**Submission to Department of Planning and Infrastructure
Sydney CBD and South East Light Rail Project
(SSI 6042)**

**Prepared on behalf of
Wansey Road Action Group**

December 2013

Figure 1: WAG preferred alignment for the CSELR in the vicinity of Wansey Road

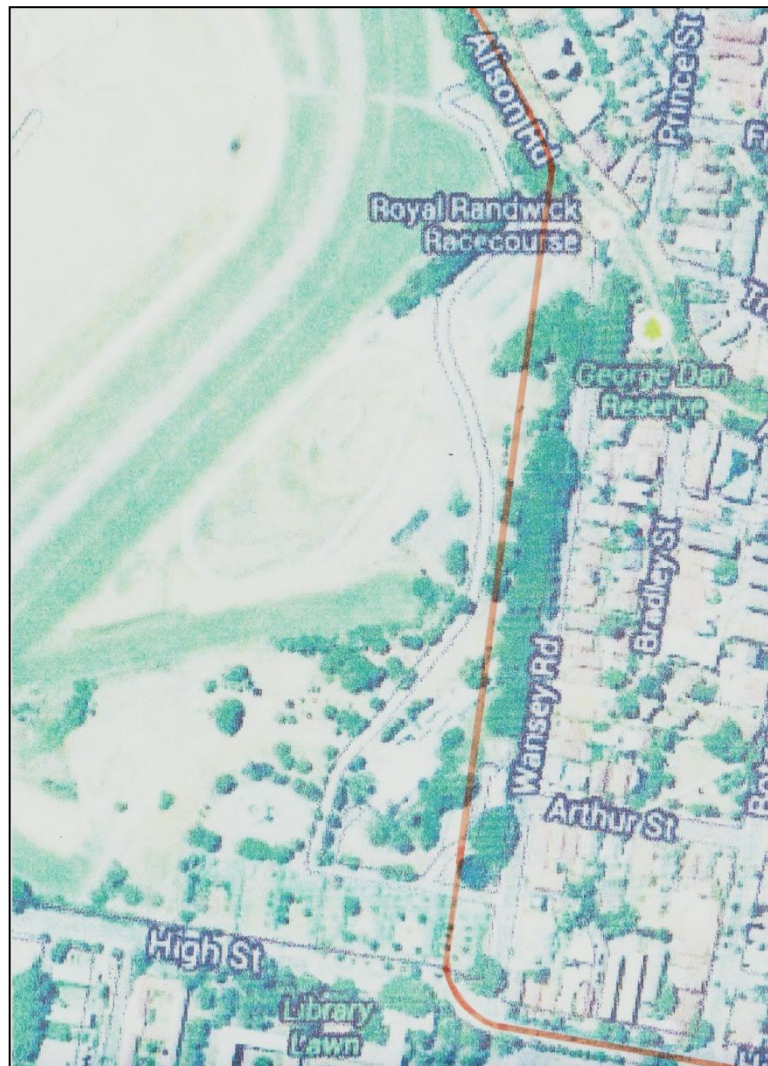
The purpose of this submission is to request that the alignment of the CSELR be altered to avoid Wansey Road by utilising land that is available within the Royal Randwick Racecourse, as shown in the image below:

This re-alignment fully satisfies the key elements considered for the design of this section of the CSELR, as noted at section 4.3.3 of the EIS, and being:

- No displacement of kerbside parking;
- No impacts to local traffic flow as Wansey Road can remain in its current configuration;
- The line would not be located in proximity to trees in Royal Randwick Racecourse directly adjacent to the Wansey Road footpath;
- It would not require re-engineering of the retaining wall currently supporting Wansey Road on its western side adjoining the Royal Randwick Racecourse;
- There would be no vertical geometry issues at the crest of Wansey Road; and
- It allows for the retention of stop locations at both the Alison Road and High Street ends of Wansey Road to serve these catchments.

Figure 11: Proposed CSELR along Wansey Road (Source: p 146 CSLER Landscape & Visual Assessment)

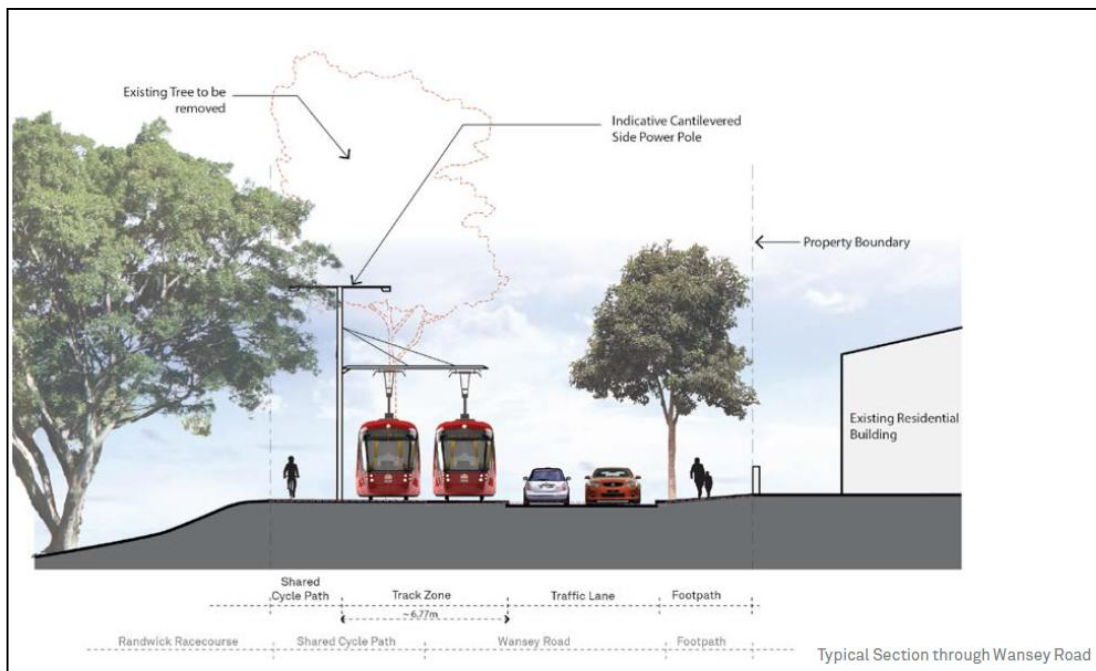
We note that Figure 5 does not appear to correlate with the EIS in that it shows the existing pedestrian pathway along the eastern edge of Wansey Road being retained - however we have not identified any confirmation of that fact within the project documentation.

Further, as noted at section 7 below, we do not understand why kerbside parking along the eastern edge of Wansey Road is shown as removed, when that is not identified at section 4.3.3 of the EIS as part of the preferred option.

Figure 13: Swept path analysis demonstrating egress movements from garages will require vehicles to cross the centre line of Wansey Road (Source: McLaren Traffic Engineers)

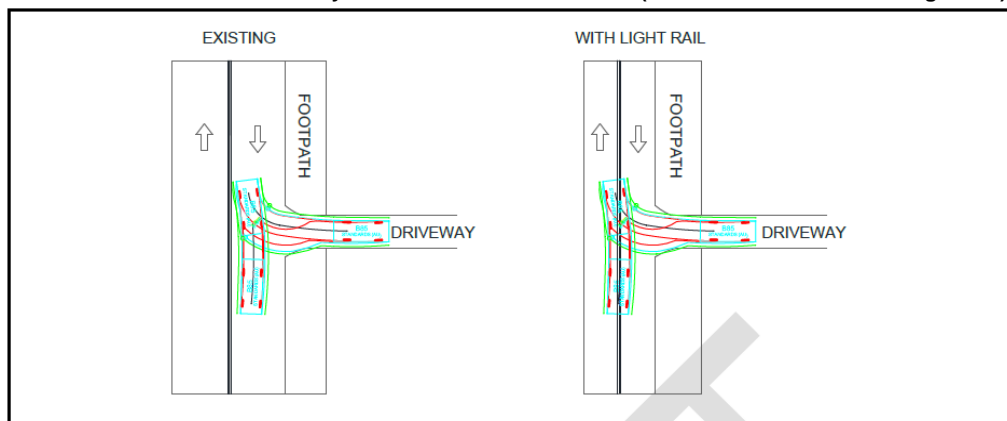
- Reversing vehicles are currently able to use the kerbside parking lane in Wansey Road to slowly back up into for a better view of oncoming vehicles before having to move into the flow of traffic within the two way road element. Eliminating kerbside parking reduces the ability of drivers reversing onto the reduced vehicular carriageway to see oncoming traffic- thereby increasing risk;

- Without this kerbside parking lane, drivers must have an unreasonably large 'head turning angle' to properly see oncoming traffic from their driveways. The 'head turning angle' to achieve the required 'cone of vision' is well beyond 1800, which is physically impossible for many drivers. The normal 'cone of vision' of the driver of a forwarding vehicle is about 750 to 1000. The risk is further inflated given that buses currently use Wansey Road (particularly Route 891 in the northbound direction) contrary to formal bus routes (see figure 4 above);

- Eliminating kerbside parking requires vehicles entering the road carriageway to cross two lanes of traffic going in both directions. The existing width from the kerb to the middle of the road carriageway is about 5m. The installation of light rail yields a distance of 3m from the kerb to the middle of the laneway, hereby increasing conflict / risk with two way traffic flow, including trucks & buses that require greater stopping distances. With the light rail, vehicles will need to cut across both lanes of traffic given the manoeuvring distance is at least 5m from the kerb, as shown in the following swept path drawings.

- The CSLER project must retain kerbside parking along the eastern edge of Wansey Road. This would improve safety for all residents of Wansey Road and all other users of Wansey Road. Importantly, it would also be consistent with the 'preferred option'

- The design of the CSLER must be altered to ensure all vehicle movements from properties along Wansey Road do not require cars to cross the centre line of Wansey Road to complete movements to/from garages serving dwellings.

Figure 15: WAG preferred alignment for the CSELR in the vicinity of Wansey Road.

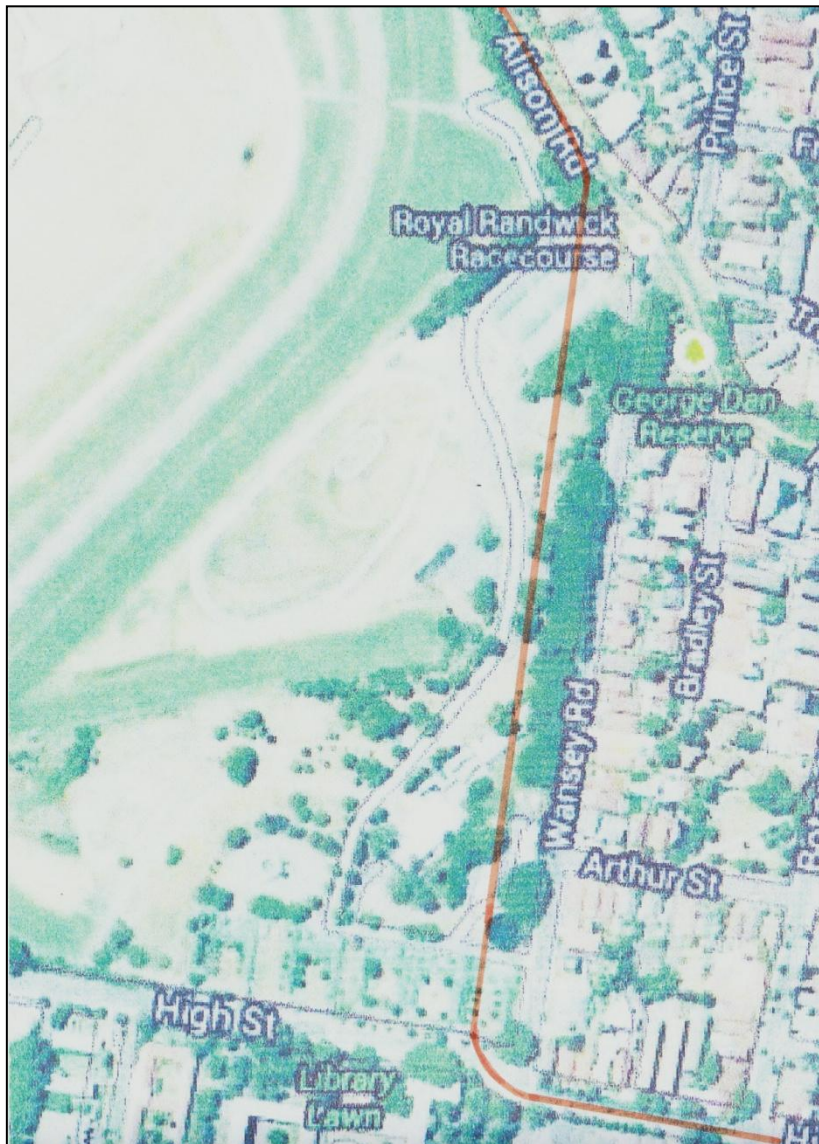
It is also disappointing that the EIS did not evaluate the preferred alignment for Wansey Road as nominated by the WAG in its pre-exhibition submission to TNSW. The preferred alignment identified by WAG is presented in the image below.

This re-alignment fully satisfies the key elements considered for design of this section of the CSELR, as noted at section 4.3.3 of the EIS, and being:

Further, WAG has identified that this altered alignment would also provide the following advantages over the option nominated in the EIS:

- No re-engineering of Wansey Road infrastructure would be needed, except for the area near the stop at the southern end of Wansey Road;
- Increased profile and physical presence of the Light Rail alignment on the racecourse property would integrate easily with the planned Urban Activation Precinct residential development of that site in the future;

Realigning the CLSER as proposed at Figure 1 (and 15) would therefore also respond to and resolve the concerns noted by Council.
